## Bulletin No. 4 of 2002: Change to Product. 31 July, 2002

### Subject: Product Change to Part #800-015 SuperMask Scuba Pod

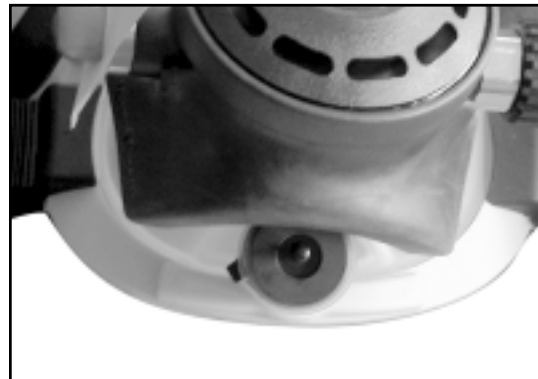
Kirby Morgan announces the addition of a tilt to purge valve to the SuperMask Scuba pod. The original pods had a dewatering valve in the chin of the pod. The new tilt to purge valve assembly is in front of the original valve. There is no part number change to the pod. The new tilt to purge valve part number is 805-047.
